**SUPPLEMENTAL MATERIALS OF PREMIER REAL  
ESTATE SERVICES II, LLC, FOR SITE PLAN  
APPROVAL, 41 RENTAL APARTMENT HOMES UNDER  
C.G.S. § 8-30g, 103 LOUIS STREET, NEWINGTON, CT**

**Newington Town Plan and Zoning Commission  
January 26, 2026**

Re: Responses to Town Planning and Engineering Department's  
January 11, 2026 Application Comments

**SSD-2**

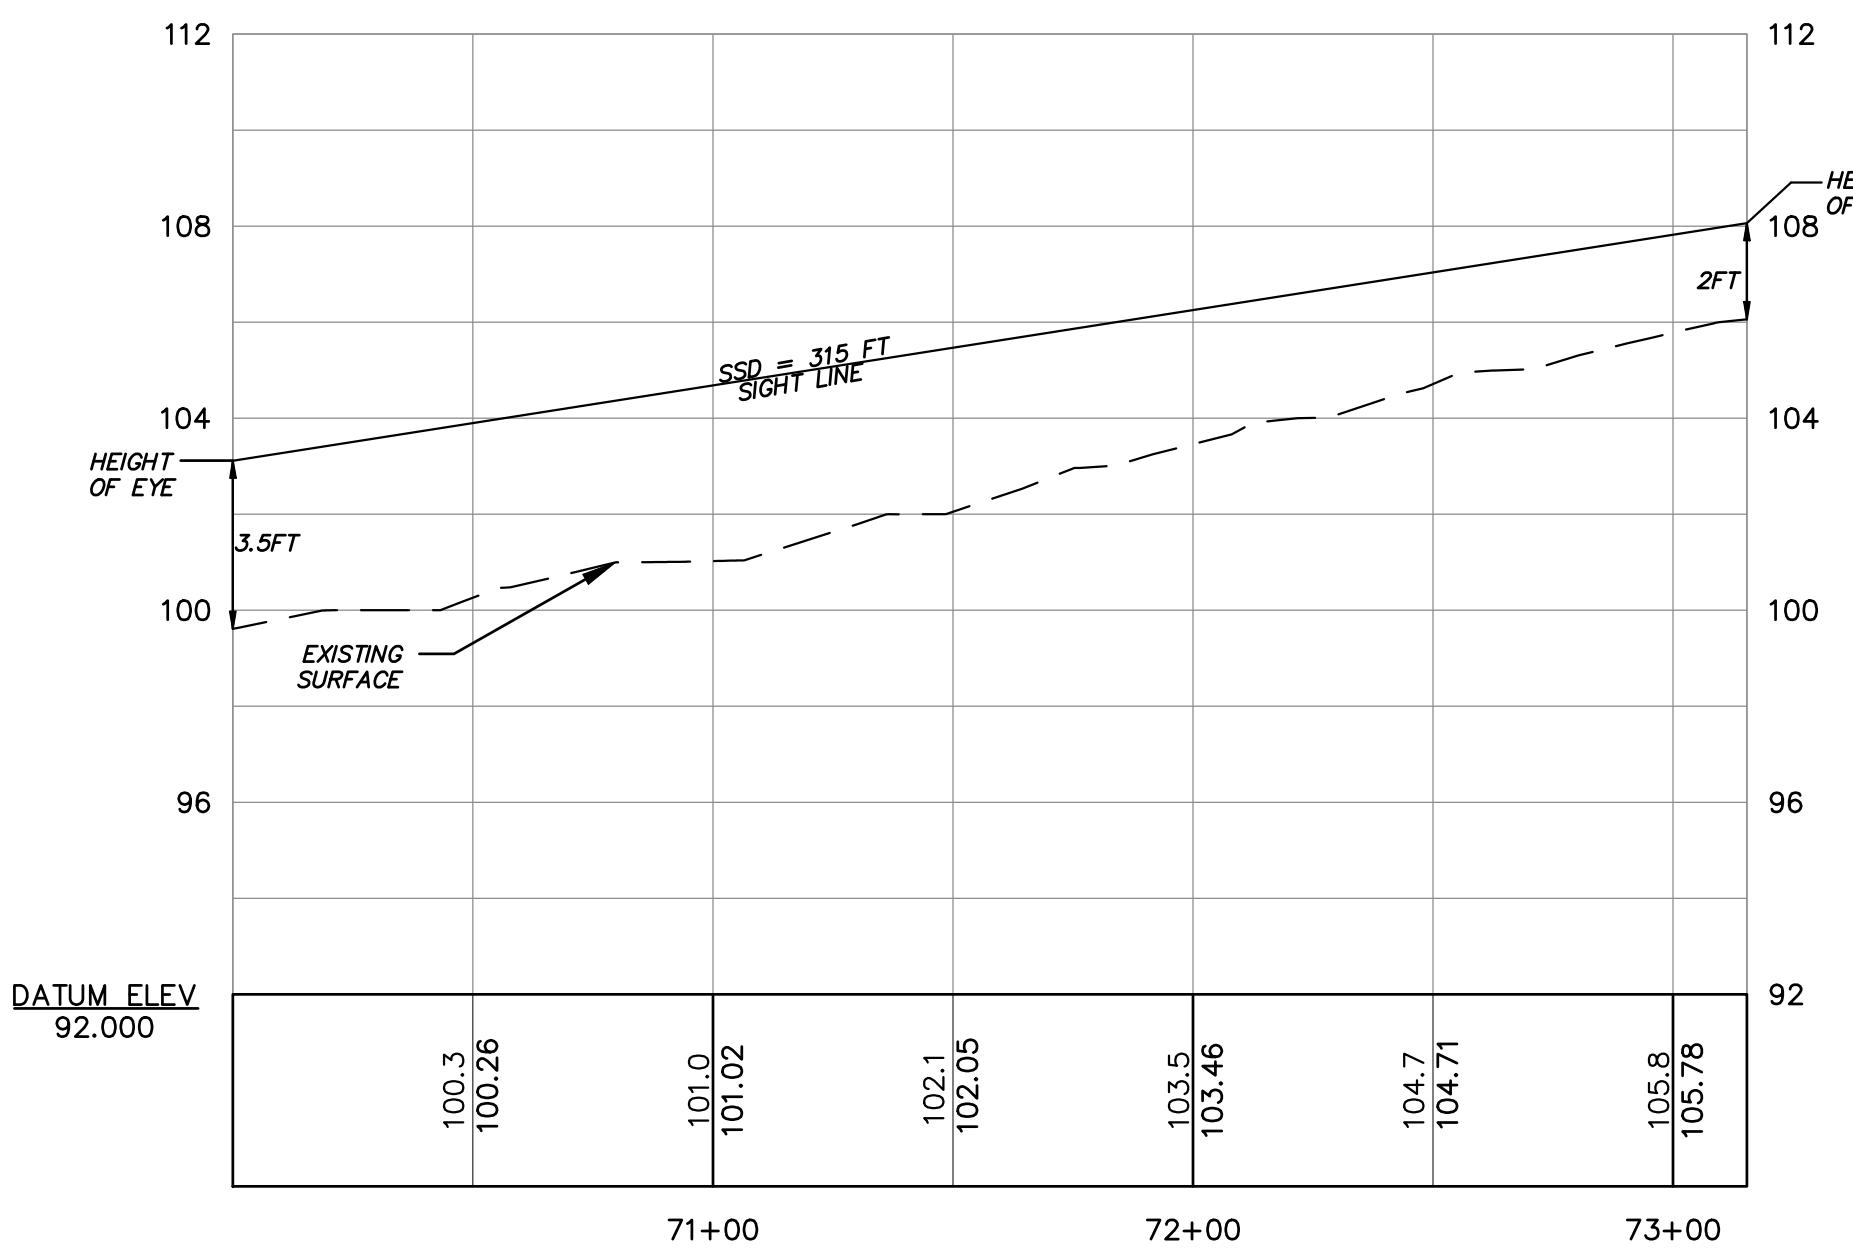
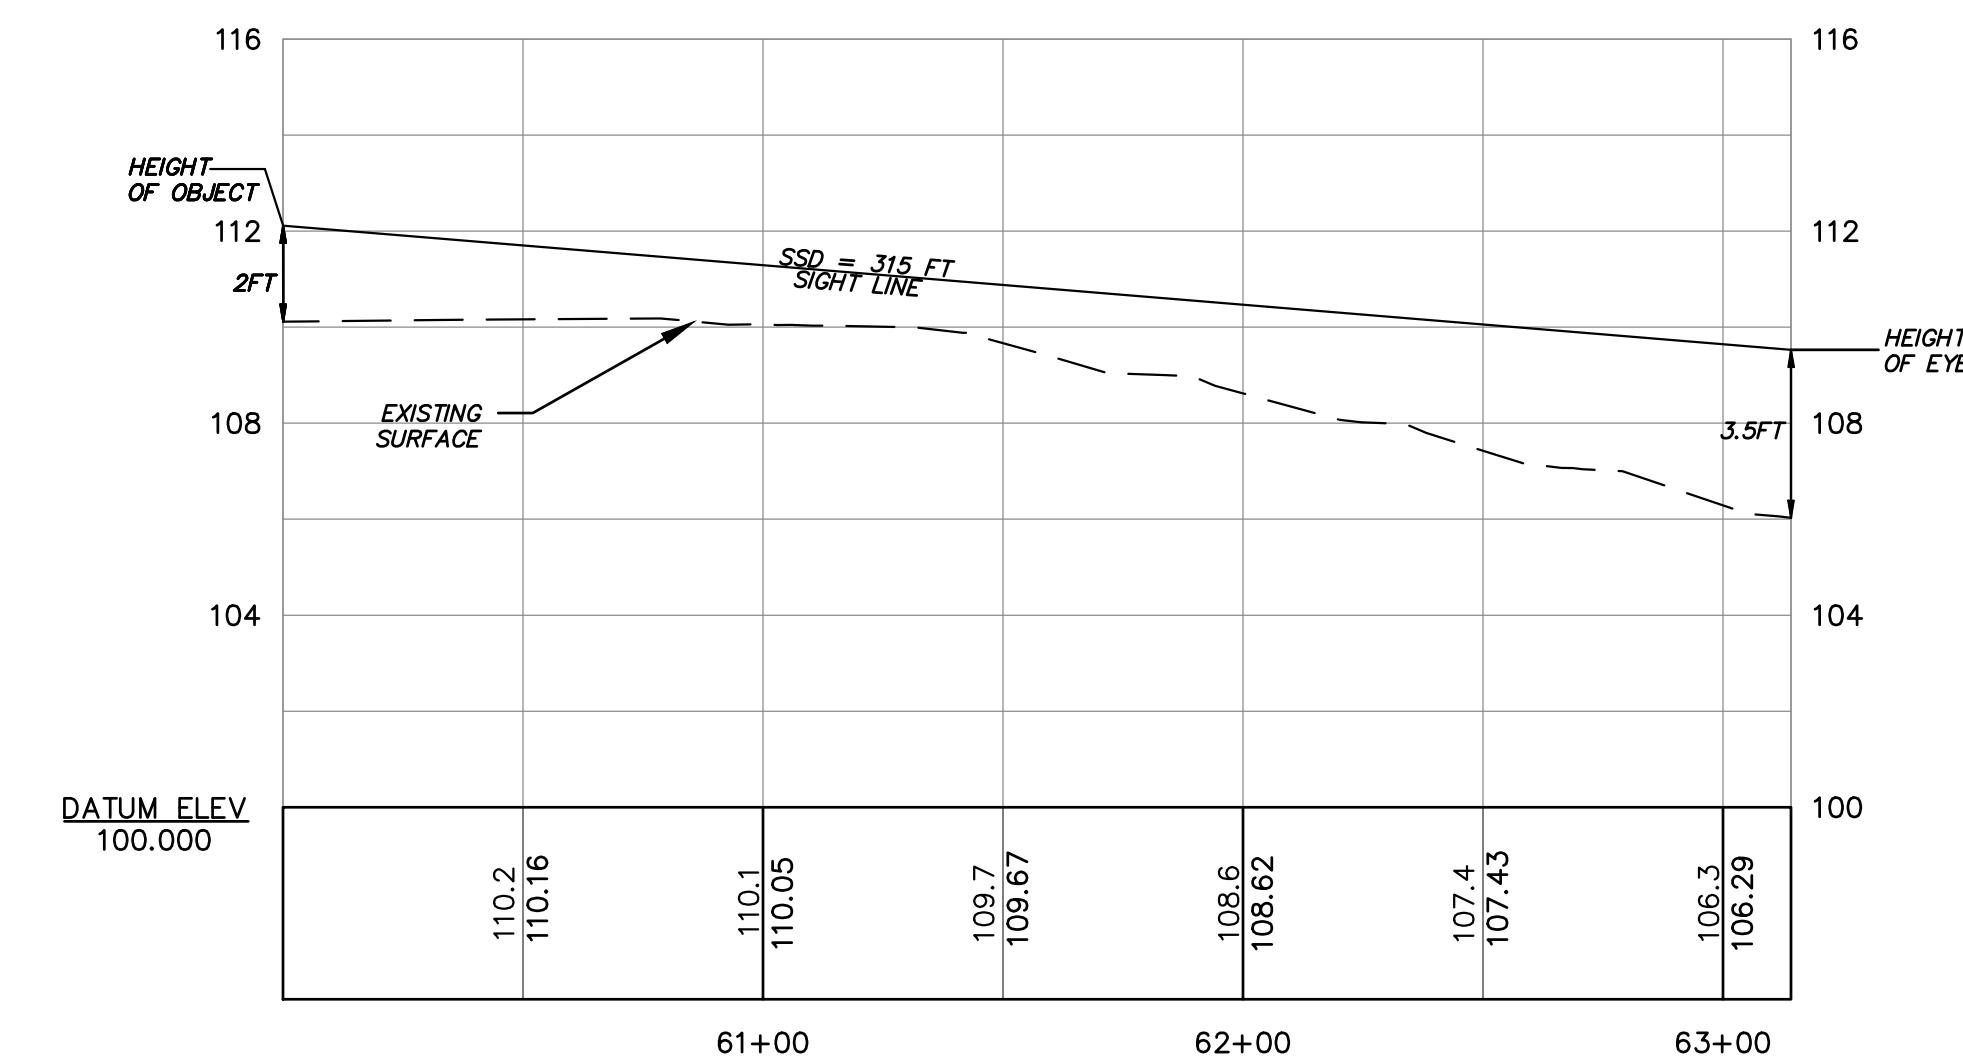
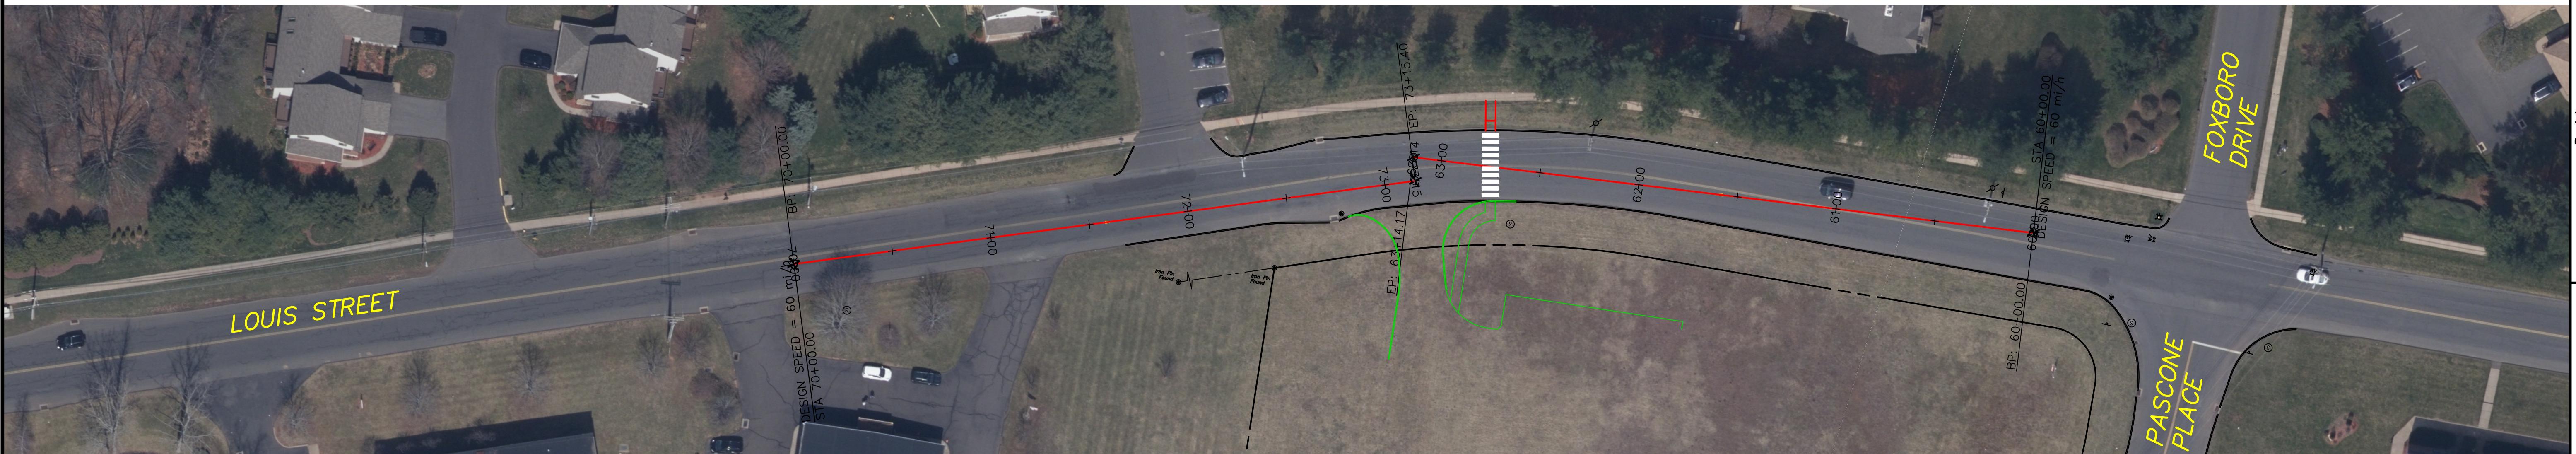
- a. *Show available and required sight lines for ISD and SSD on the site plan (Traffic Report).*

- a. *The traffic report includes the available sight distances and states that "The available sight distances meet the current ConnDOT criteria for an approach speed of 40 miles per hour." Please include the calculated minimum required Stopping*

*Sight Distance and Intersection Sight Distance for cars traveling on Louis Street and Pascone Place and exiting the site driveways in the report. In addition, speed data is not presented for Pascone Place and information on the 85% percentile speed should be included for the calculated sight and stopping distances.*

**RESPONSE:** The applicant has included in its supplemental materials a plan and profile sheets showing the minimum required Intersection Sight Distance (ISD) and minimum required Stopping Sight Distances (SSD) for the driveway.

**RESPONSE:** A speed count was conducted on Louis Street April 14<sup>th</sup> through April 21<sup>st</sup> 2015. A copy of the count is included in the appendix of the original report. The measured 85% speeds were 37 mph and 40 mph for the eastbound and westbound directions, respectively. Based on Table 11-2C, the minimum required ISD for 40 mph is 445 feet. The minimum required SSD, based on Table 7-1A, is 305 feet on level ground and 315 feet on a 3% downgrade.
